Project:	LTWP - Critical Pipeline Renewals 2026-RFT-009	No. of Pages:	10
Addendum No.:	1	Date Issued:	April 14, 2026

The following change(s) in the Request for Tender Documents 2026-RFT-009 are effective immediately. This Addendum forms part of the Contract Documents.

TITLE ACCESS VAULT DETAIL		DWG NO. A-003
	DATE FEBRUARY, 2026	SCALE N.T.S

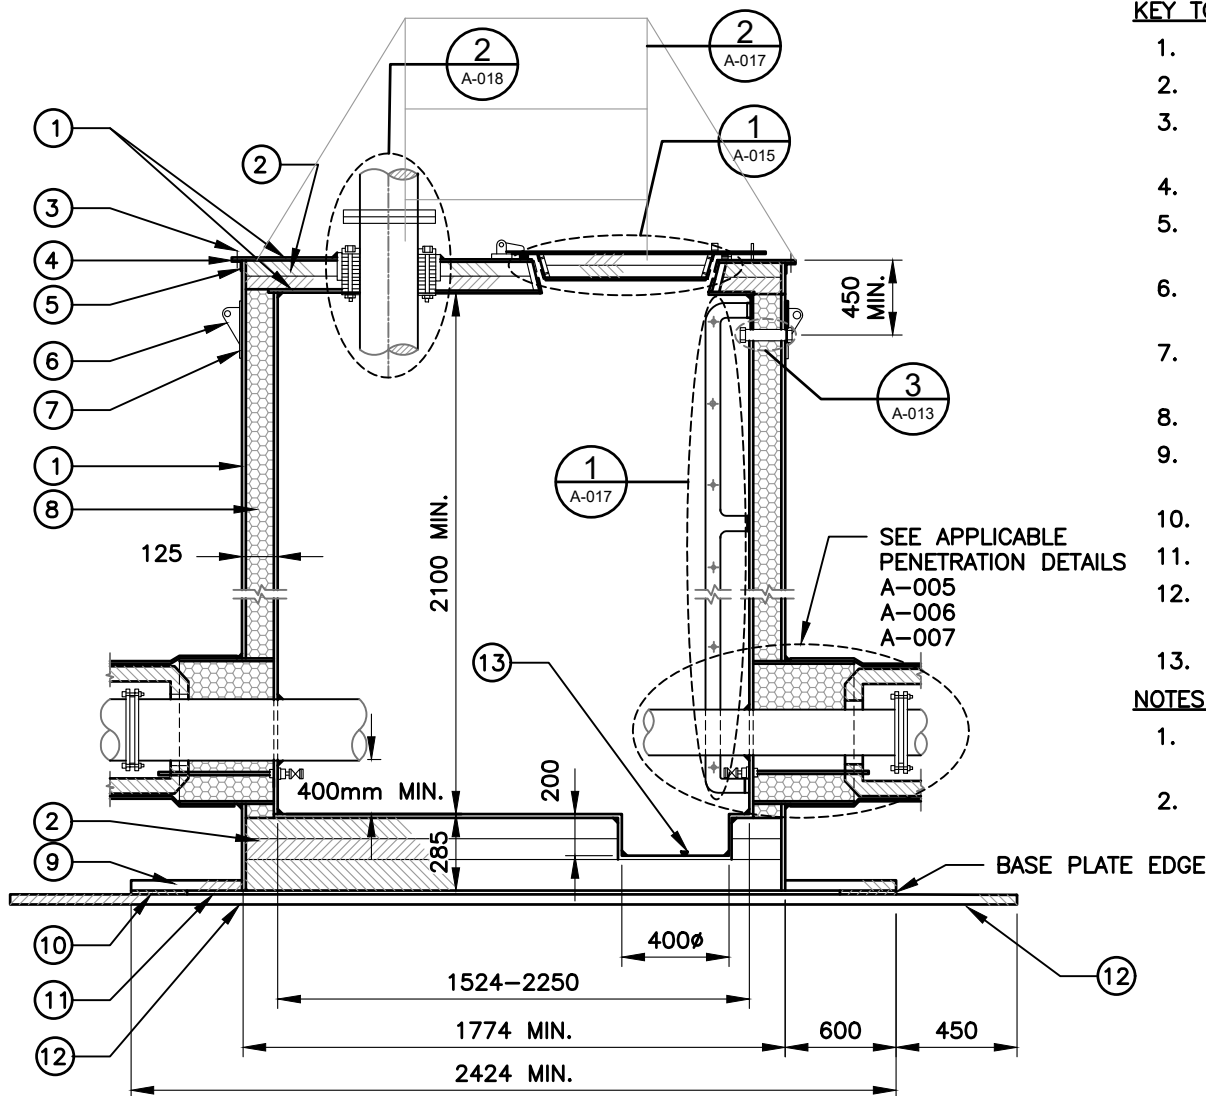
Please provide dimensions from invert to base plate or invert to top of inside bottom as seen below on drawing C1004 detail 1.

The minimum separation between the underside of piping and the floor of the AV is 400mm. as shown in detail A-003 attached in Appendix B.

TITLE ACCESS VAULT WALL PENETRATION WATER MAINS		DWG NO. <h1>A-005</h1>
	DATE FEBRUARY, 2026	SCALE N.T.S

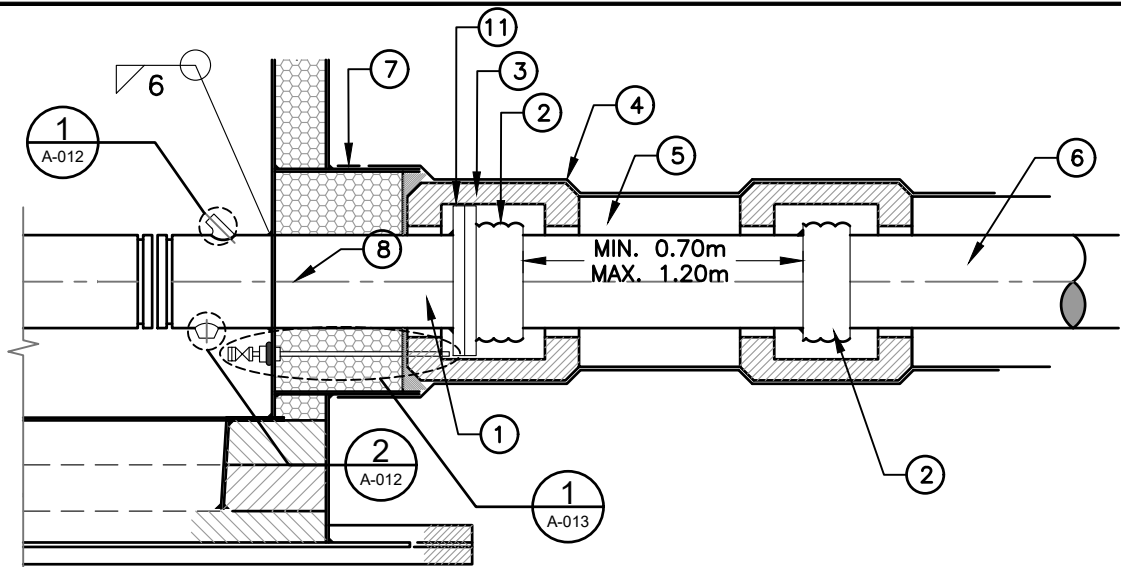
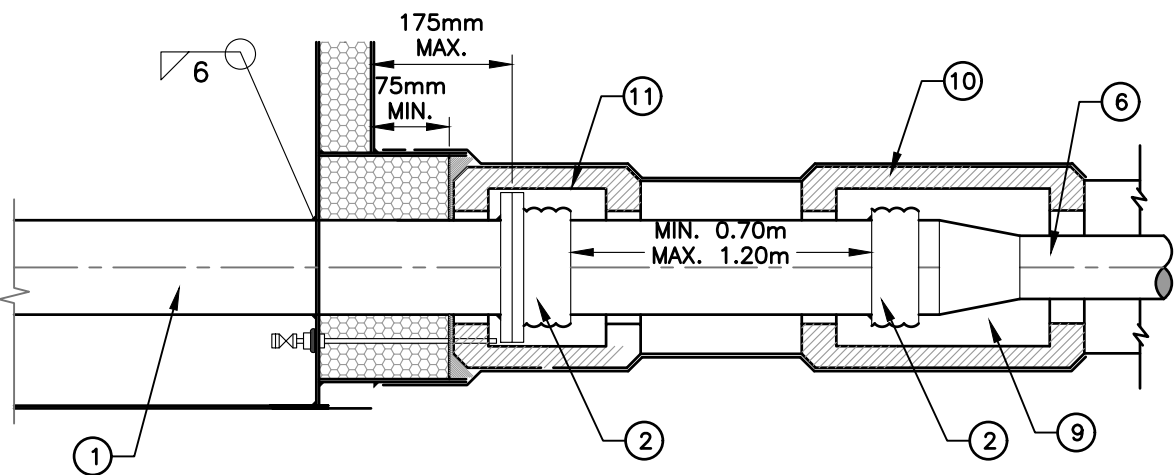
Per section 33 05 14 – 2.1.8.2 it indicates all flexible couplings to be Victaulic 257 Dynamic Movement Joints or approved equivalent. Would the George Fisher Multijoint Coupling be an acceptable equivalent, if so, please detail installation.

Yes, the George Fisher (GF) Multijoint coupling will be an acceptable alternative to the Victaulic 257 Dynamic Movement Joint. Flexible couplers must be installed as per detail A-005 for watermains and A-007 for sanitary sewers. Details are attached in Appendix B.
